ADDENDUM

Forestside Estates
Attmar & Palleschi Drive
Brampton, Ontario
Attn: **Vince Staffieri**

AM 08

PROJECT	**: Forestside**
PROJECT #	**: 1331.15**
DATE	**: Jan 18, 2021**

SECOND FLOOR OVERALL PLAN

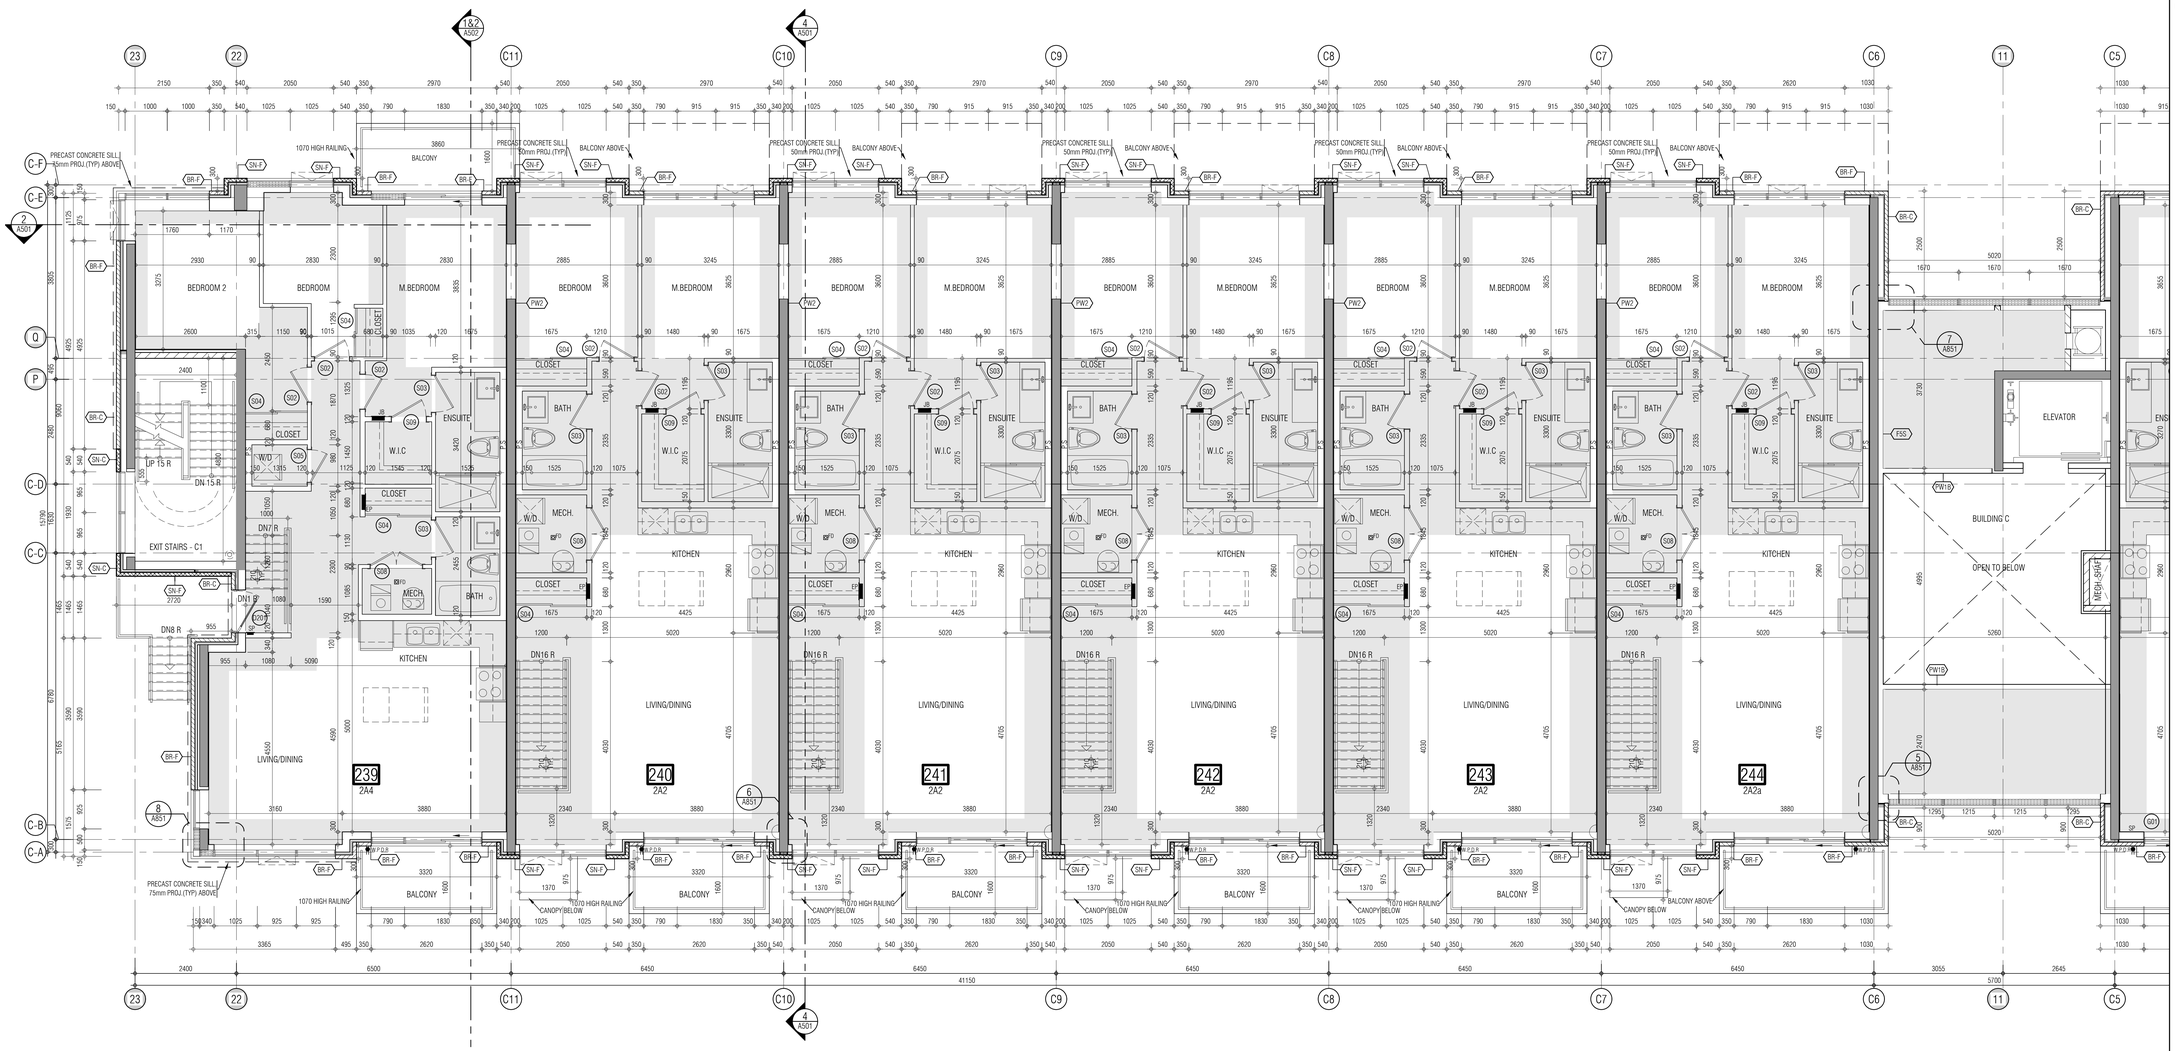
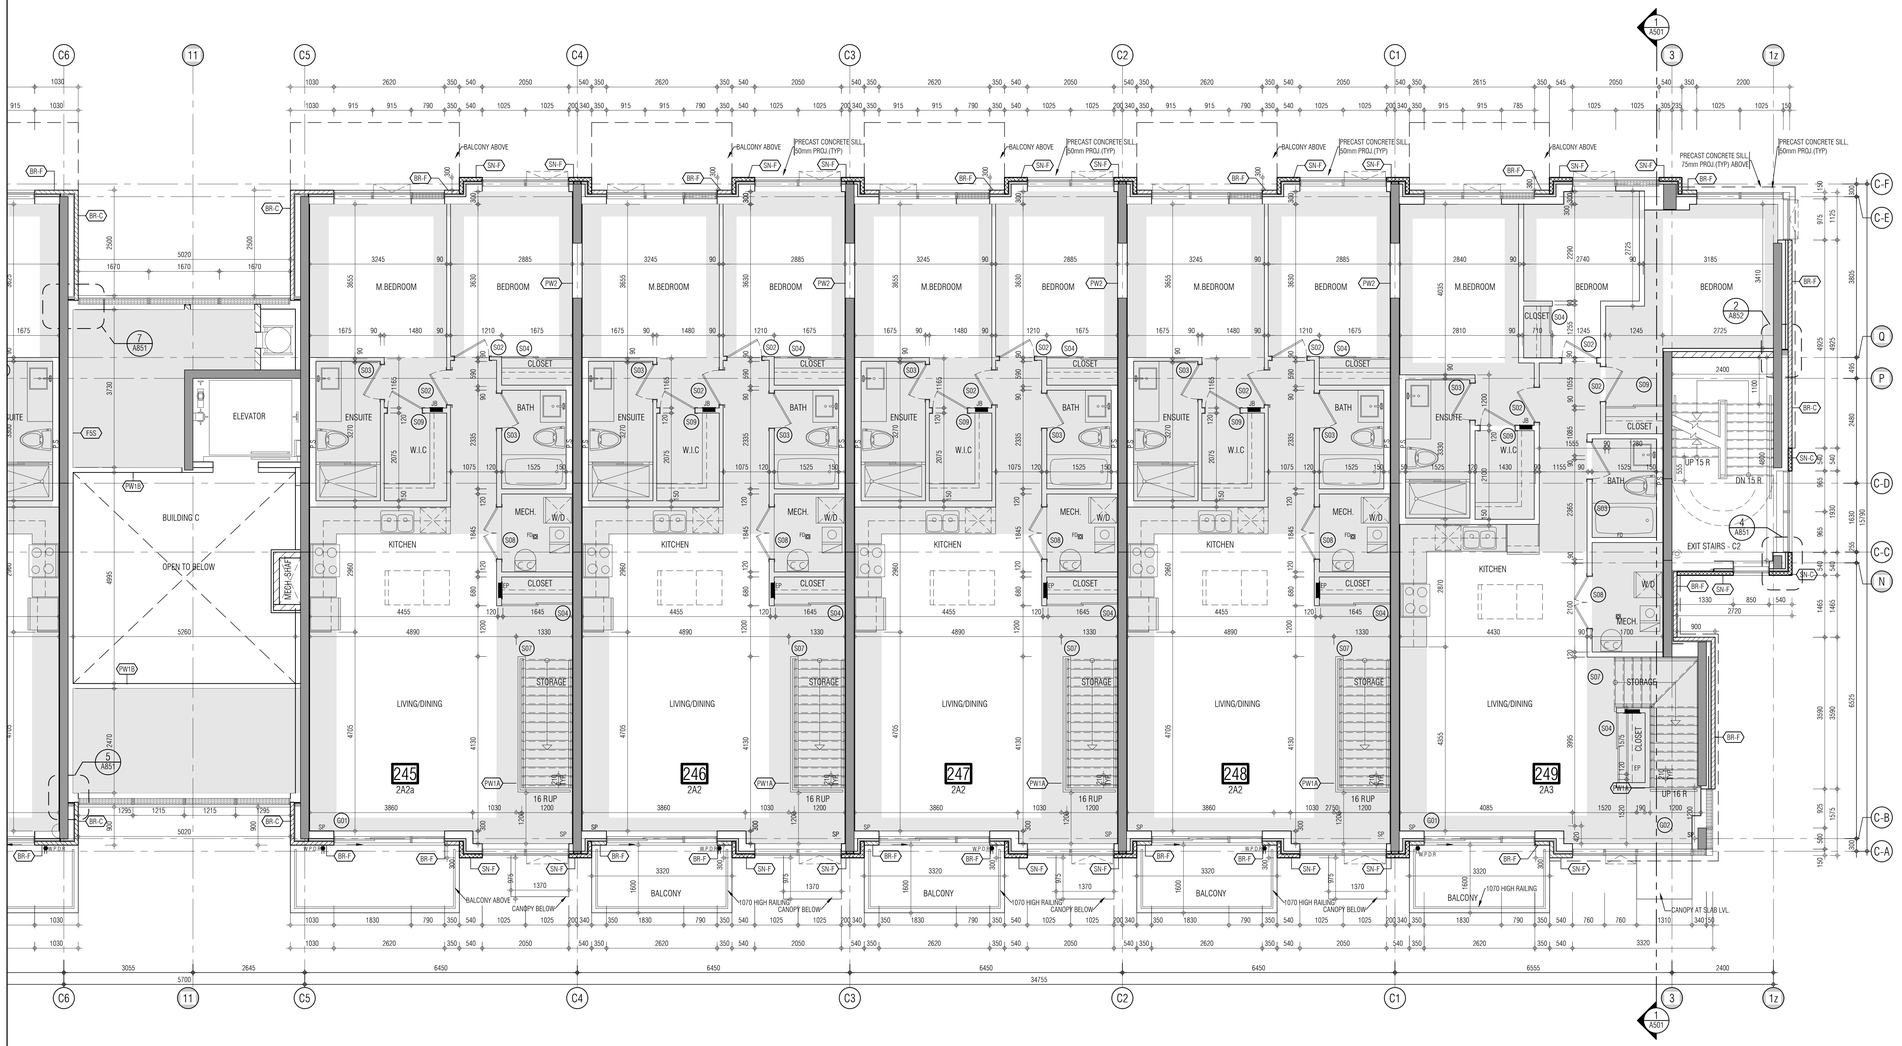
A301-A304	1st – 4th Floor Plans	• Move Blocks A and B north 286mm to comply with 0.3m easement and 3.0m minimum set back to property line as per clients request. • Move Block D up 390mm along angle north to comply with 0.3m easement and 3.0m minimum set back to property line as per clients request.
A701a-A701b	Stair Sections	• Revised dimensions on stair plans to match blocks that were moved.
